Decision

ElectraNet Heywood Interconnector Upgrade Contingent Project

28 March 2014

Figure 1 is a diagrammatic view of the electricity network changes that are proposed.

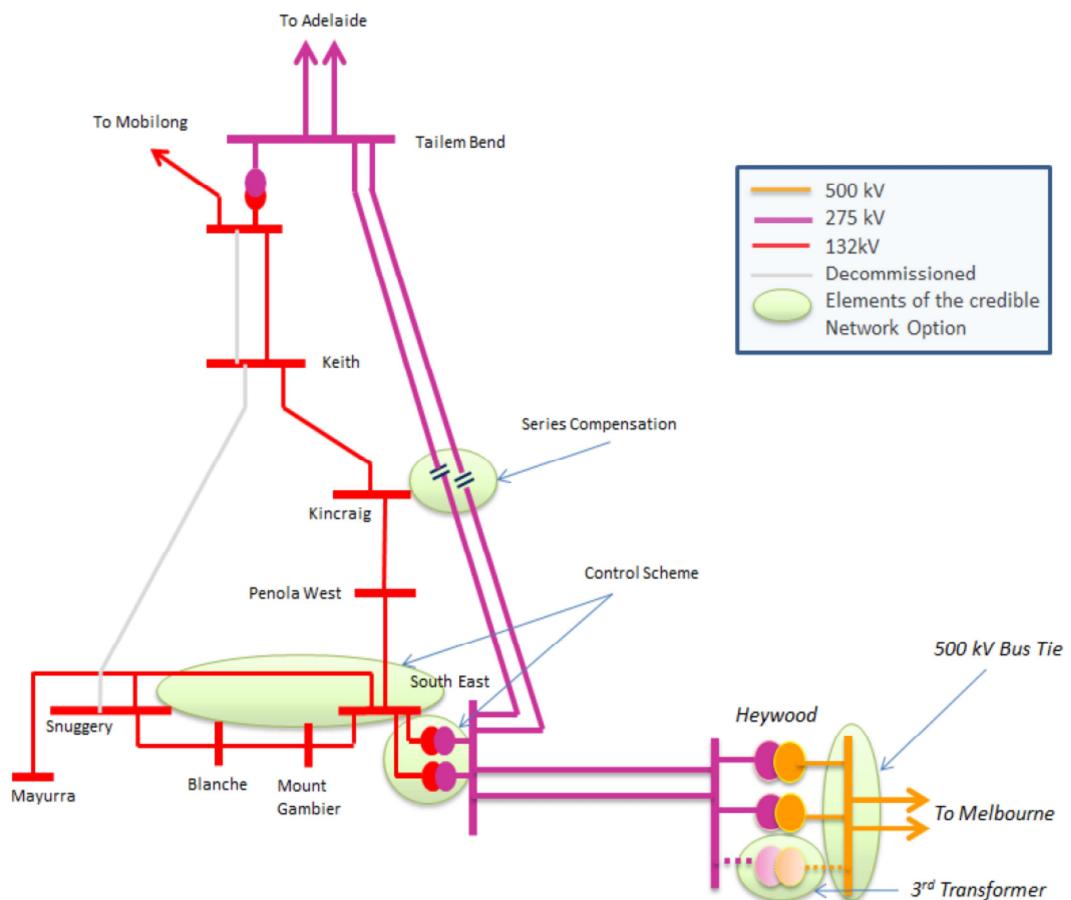
However, we do not agree that the demolition of two redundant transmission lines should occur immediately. ElectraNet proposed two lines be removed on safety grounds at a cost in excess of \$20m. To justify this ElectraNet applied a very high safety standard. We consider an efficient business would not incur these high costs when a safe, lower cost alternative option is available. Our preferred alternative is a passive safety program involving de-energising the lines, conducting a safety audit, repairing defects that pose a safety hazard and regularly patrolling the lines.

Note: The two lines marked in grey are to be decommissioned.

We agree with the need to remove these two 132kV lines from service but we do not agree they should be demolished immediately. Our examination of the proposal identified the high cost (i.e. \$18.62m plus \$2.2m on-costs including \$0.98m risk allowance (\$2012-13)) of works in decommissioning the two existing 132kV lines as requiring further justification. We also identified a number of issues with the NPV analysis ElectraNet used to calculate the optimum timing. ElectraNet's model seeks to assess potential future need for network assets in the South East region on a long-term view.

- incorporation of the south east control scheme is warranted;
- the demolition of two ElectraNet 132kV transmission lines numbered F1836 and F1837 as proposed by ElectraNet should not be included in this project;

Our view is the lines should not be demolished immediately. This view leads to a substitution of ElectraNet's proposed capital expenditure with operating expenditure. This also changes the effective date for completion of the project. We consider that ElectraNet should adopt a passive monitoring program commencing with an immediate condition survey in 2016-17 and repeated at 5 year intervals at an estimated cost of \$300k (2012-13). Additionally, the lines should be subject to ground or aerial
